National Public Hearing on Technical Review Report for PL HPP

At 6th Regional Stakeholder Forum/2nd Regional Information Sharing
17th January 2019, Luang Prabang, Lao PDR

4. Discussion on Technical Review Report (DRAFT 2.0)

Ship lock Simulation Model

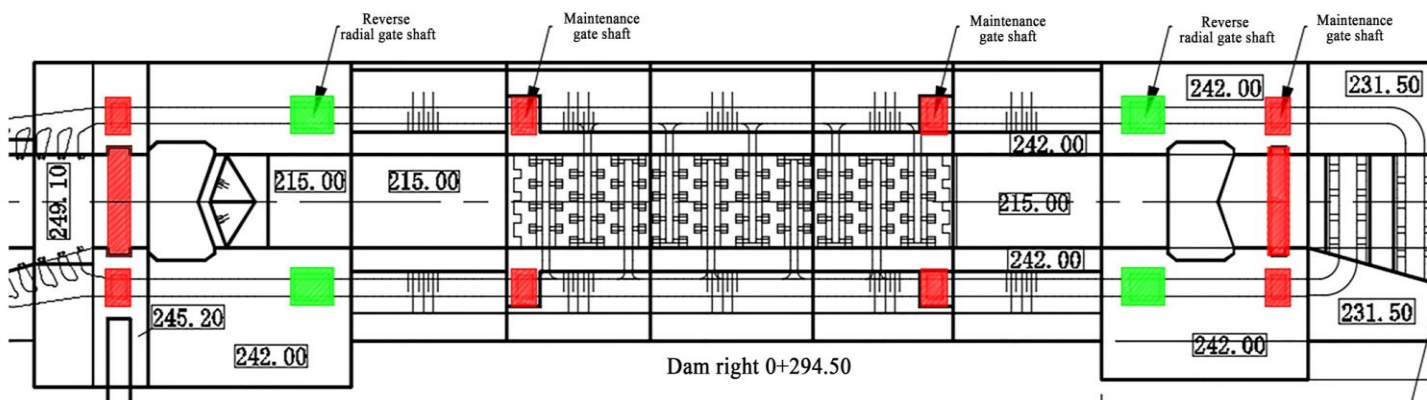
Discussion on TRR (Navigation)

- In the detailed design stage, the air clearance could be raised minimum 10m in order to meet the requirement of the height over the upper lock head.
- Excavated channel during project construction for 2nd ship lock and its drawing is available now
- Ensure that ship lock of Pak Lay HPP could enable the safe navigation of any ship that is smaller than the design ship size.
- Confirmed ship lock of Pak Lay HPP could enable the passing of 500t ship with 120m x 12m x 4m size
